# TOWN OF GLASTONBURY

GL-2023-12

## FIRE HOUSE IMPROVEMENTS

ADDENDUM NO. 4

DWG. NO.  
**FP1**

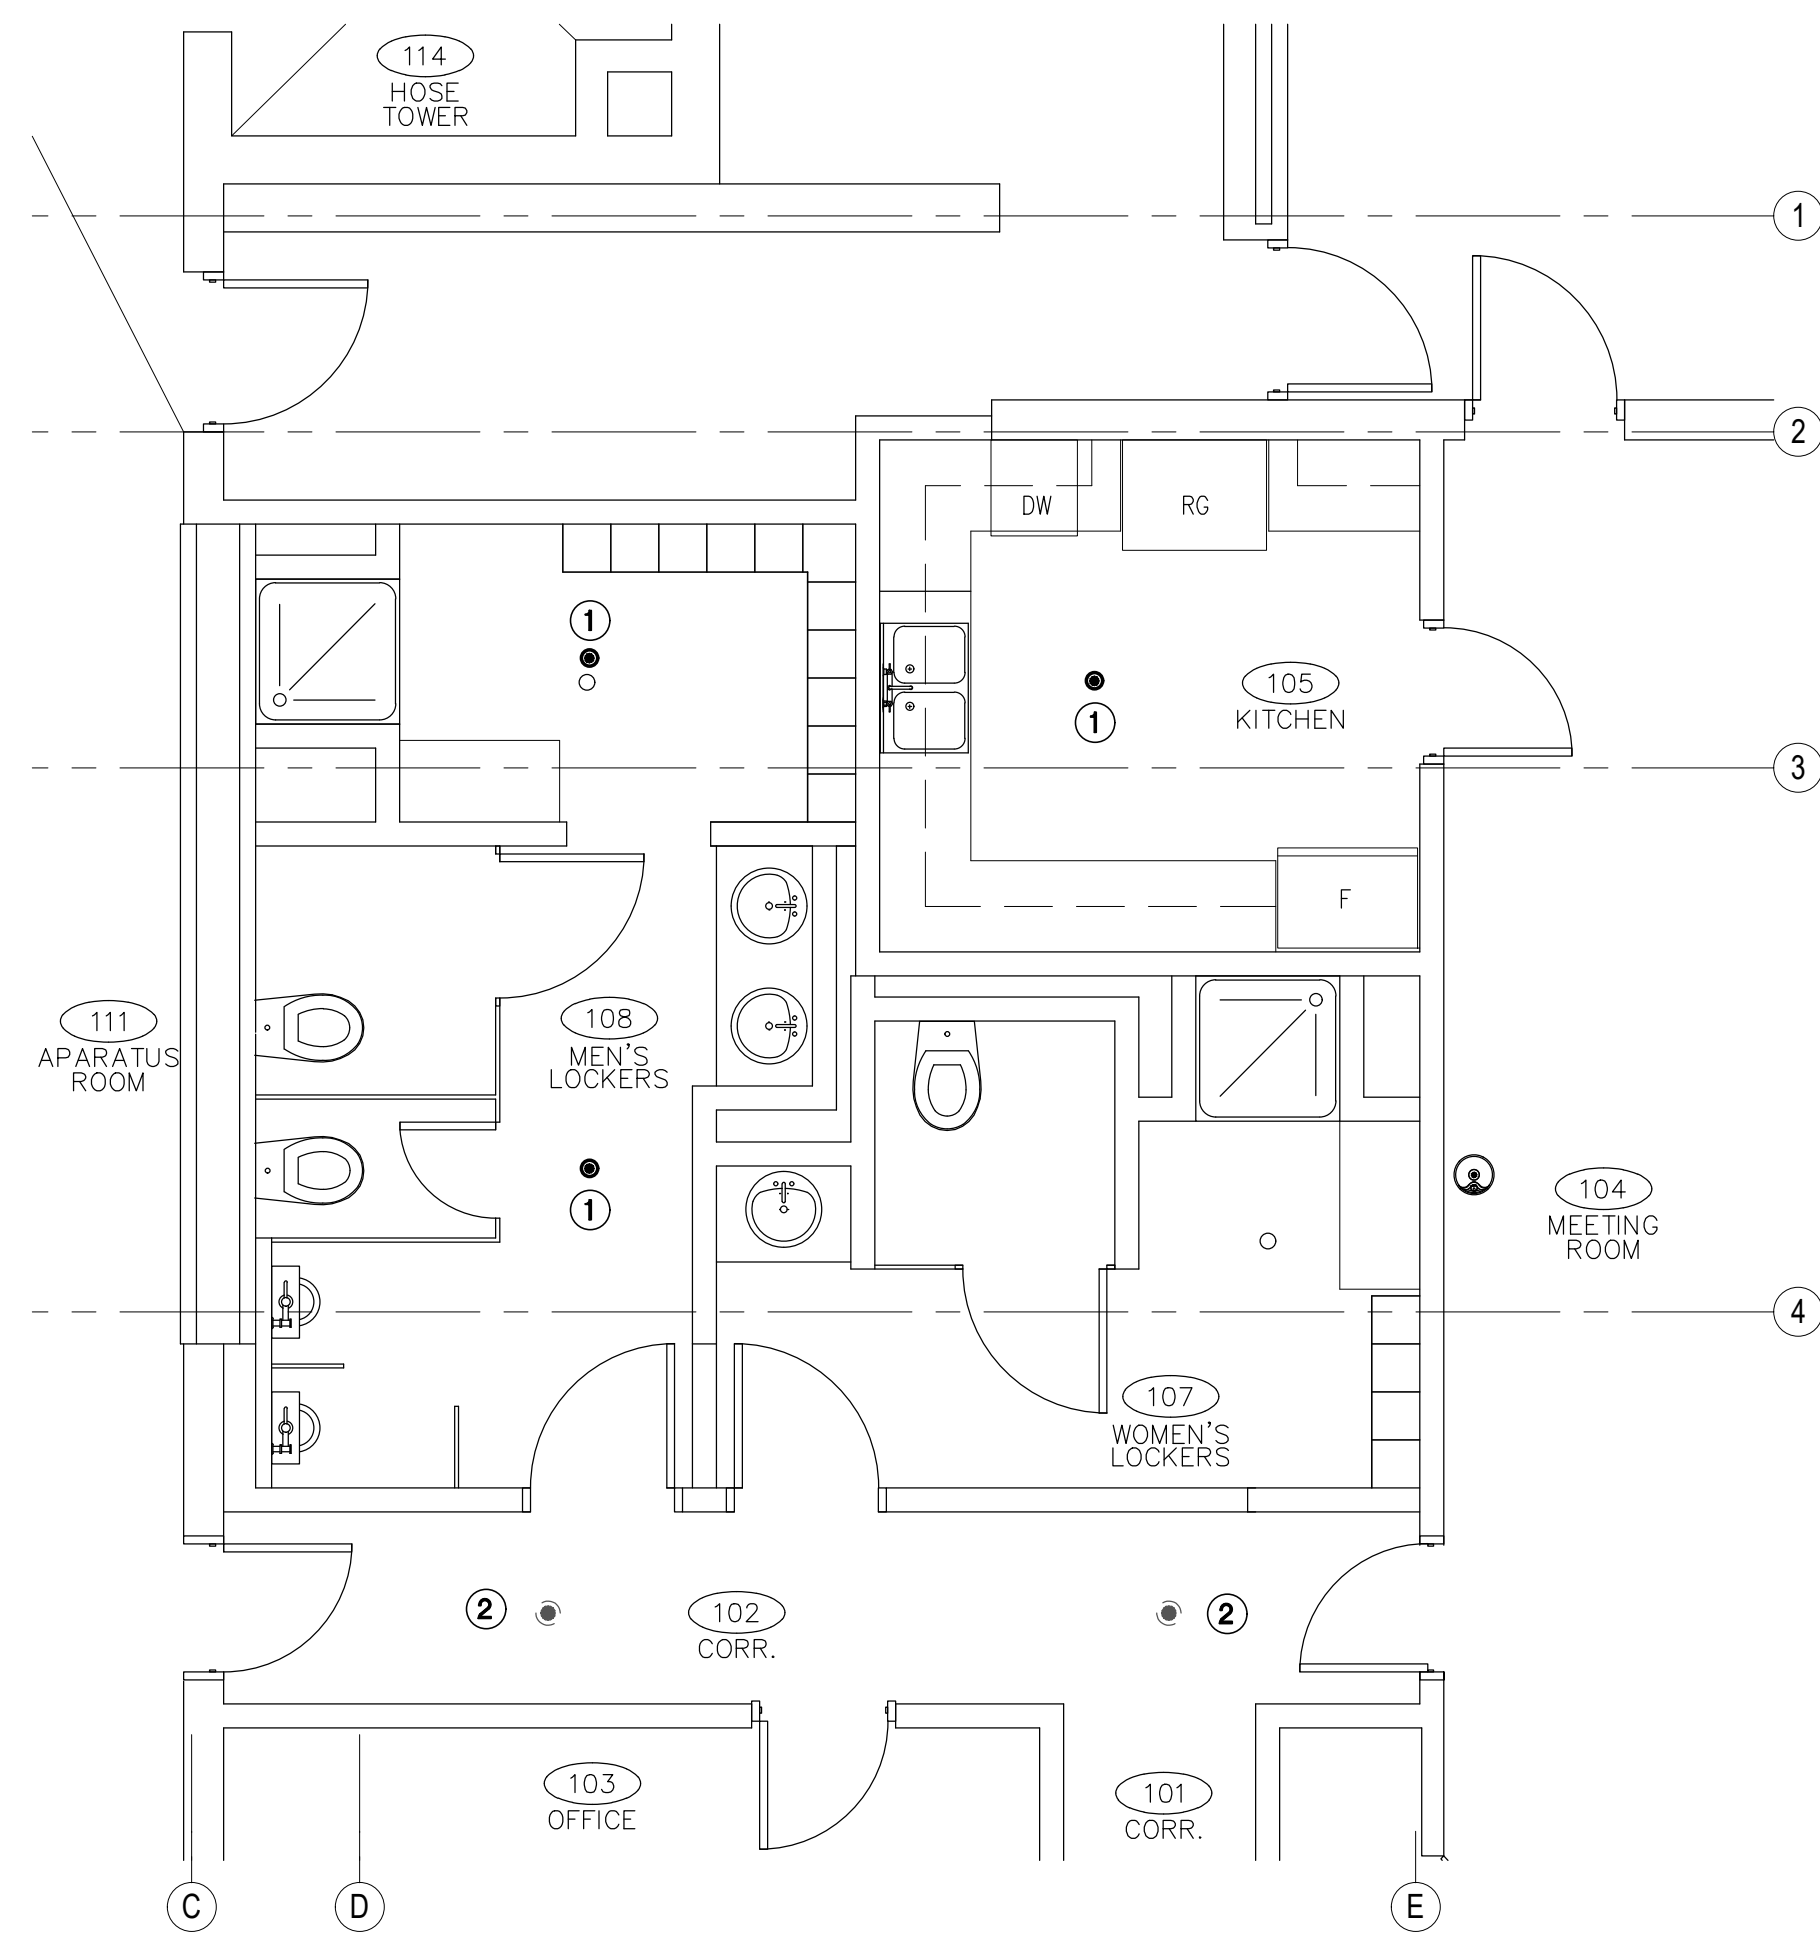
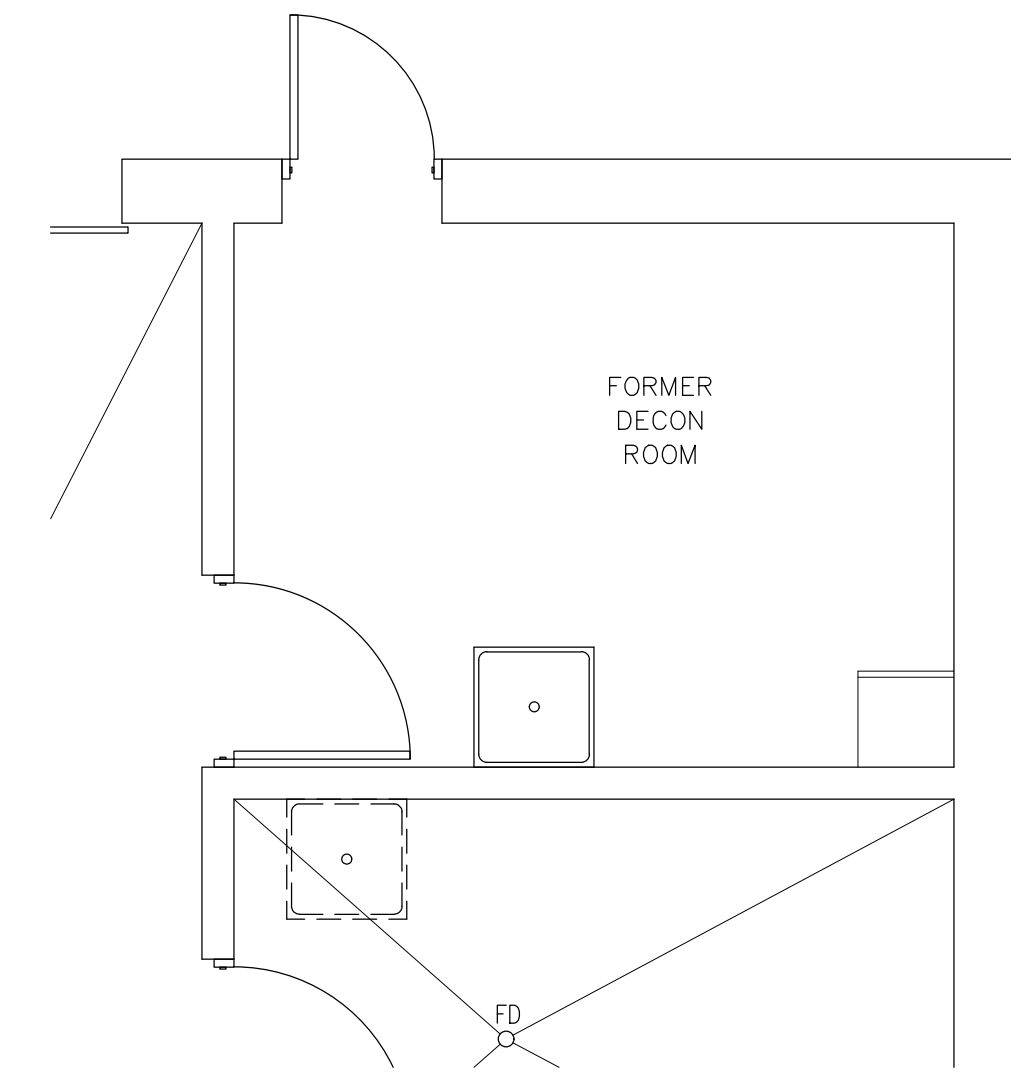
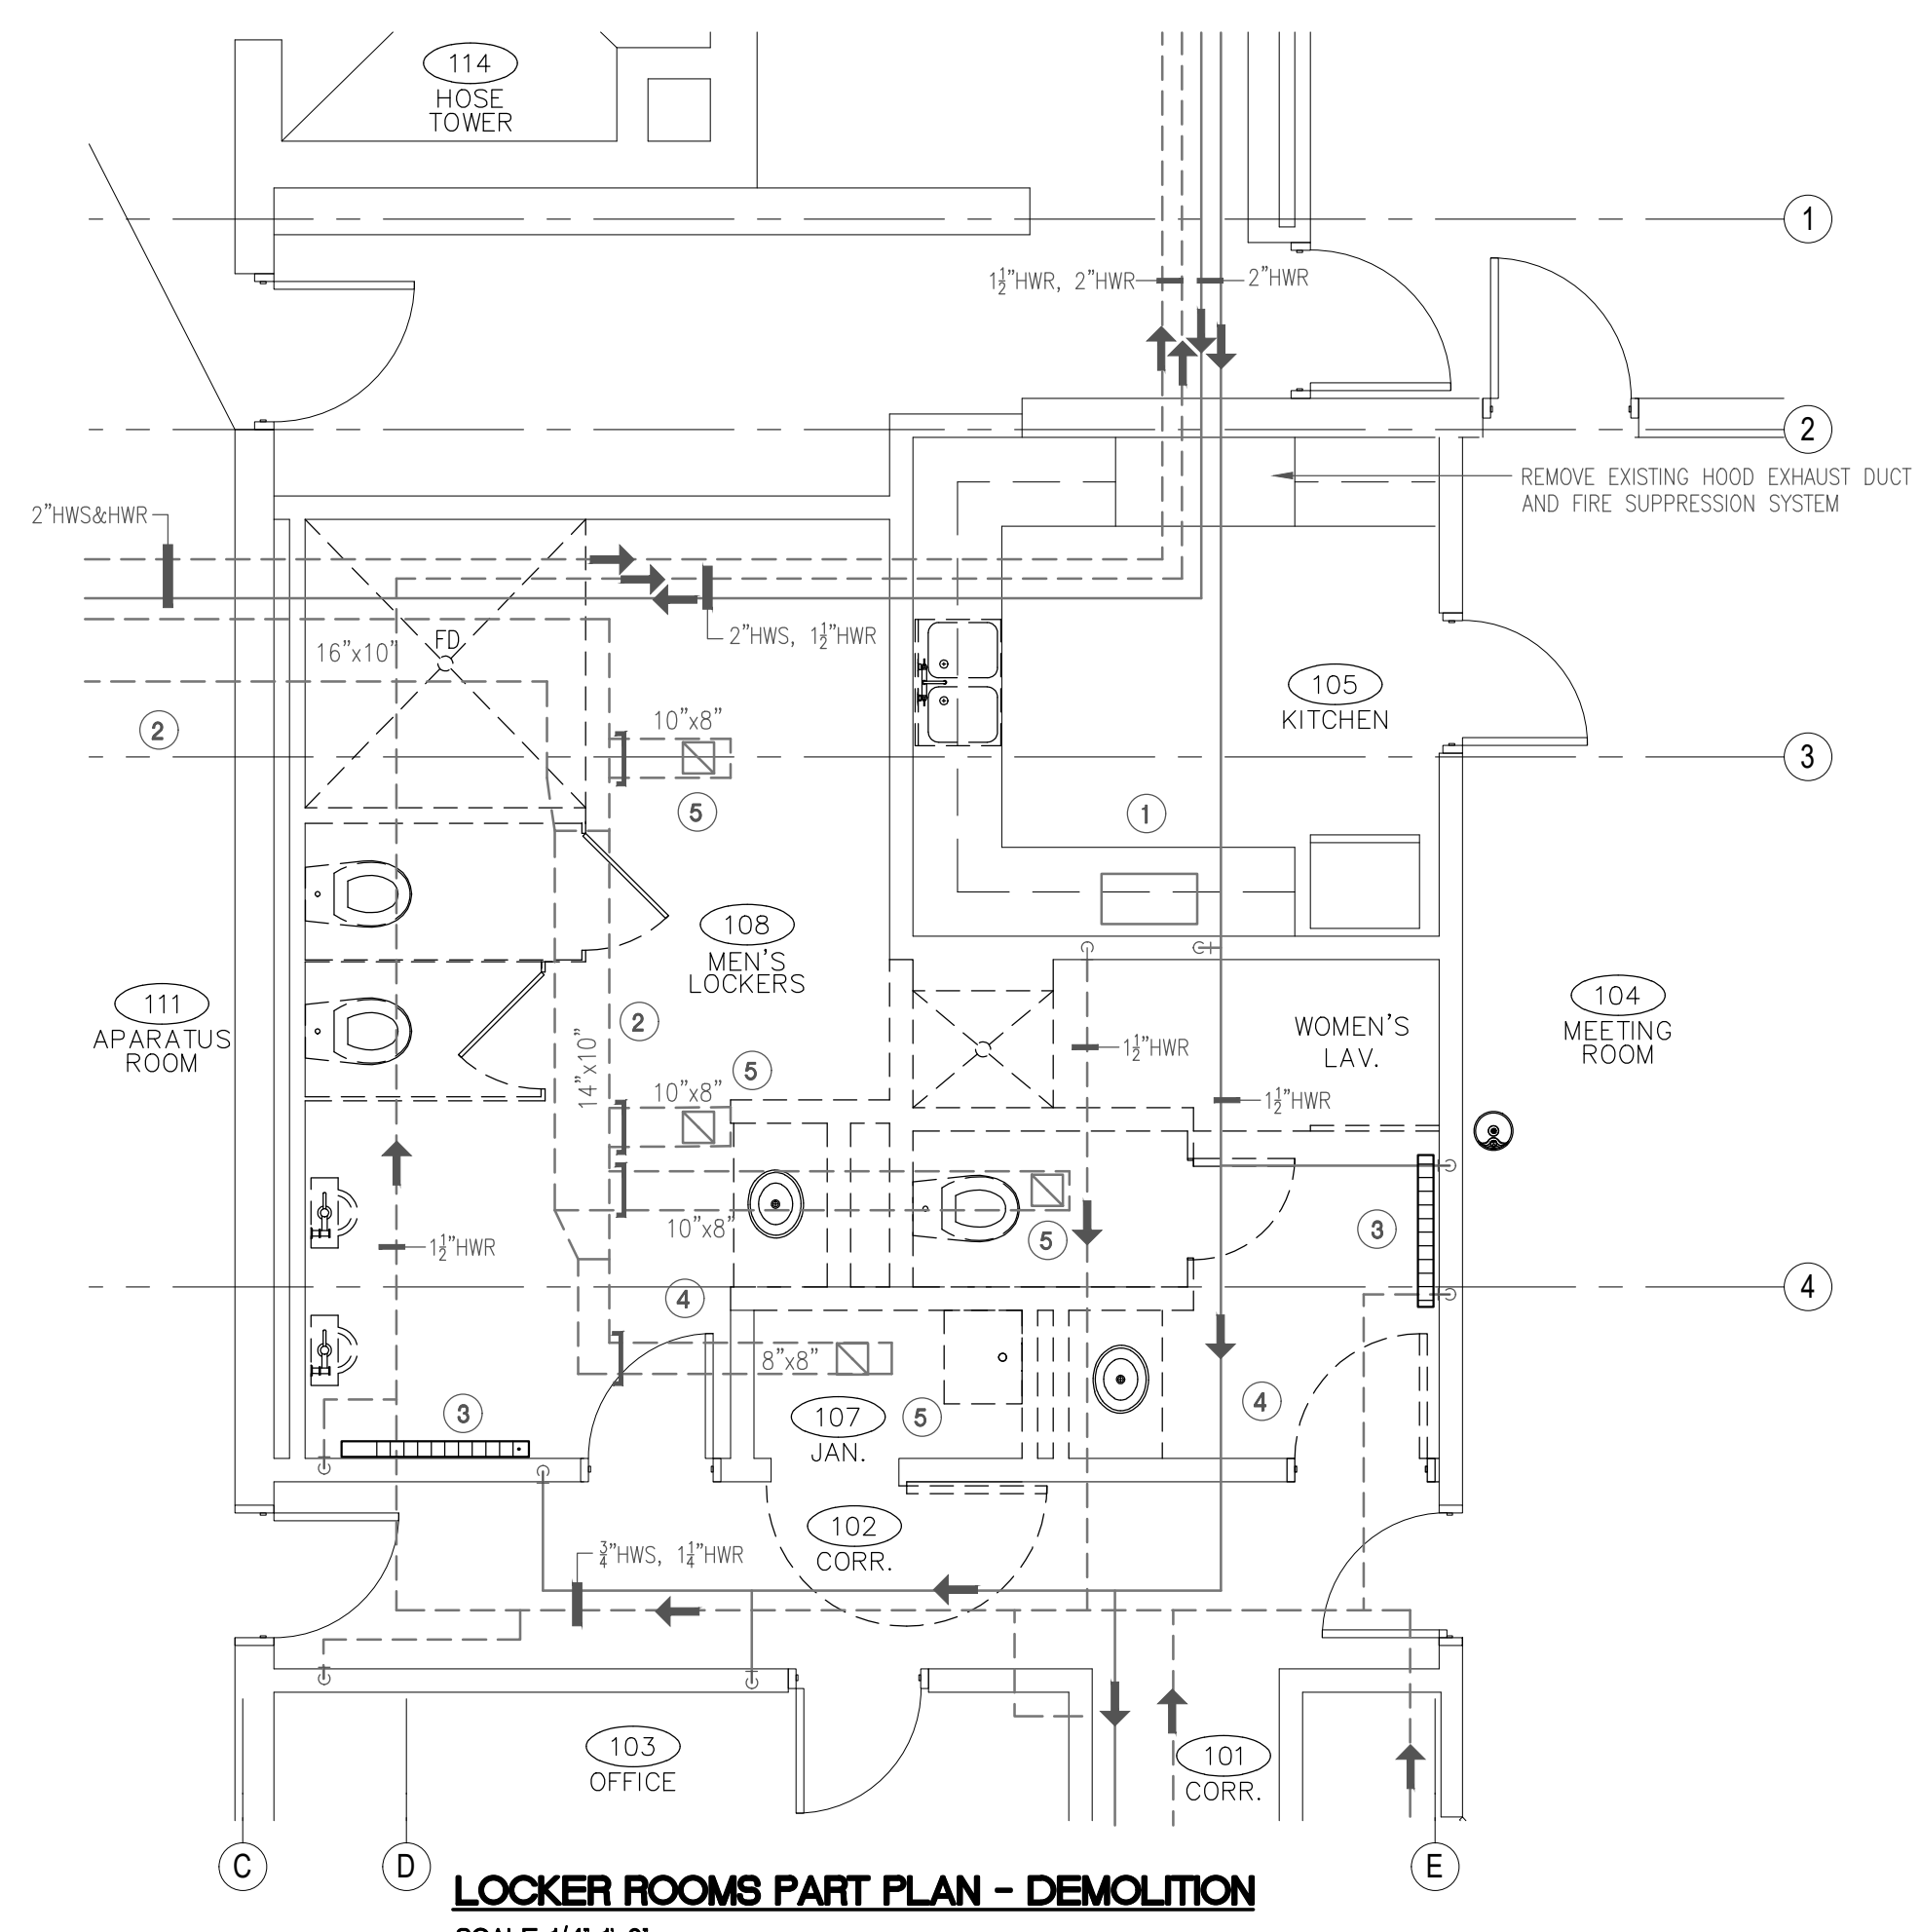
**Question 9:** *Please clearly define the extent of the sprinkler work the contractor is responsible for.*

**Answer:** See Drawing FP1
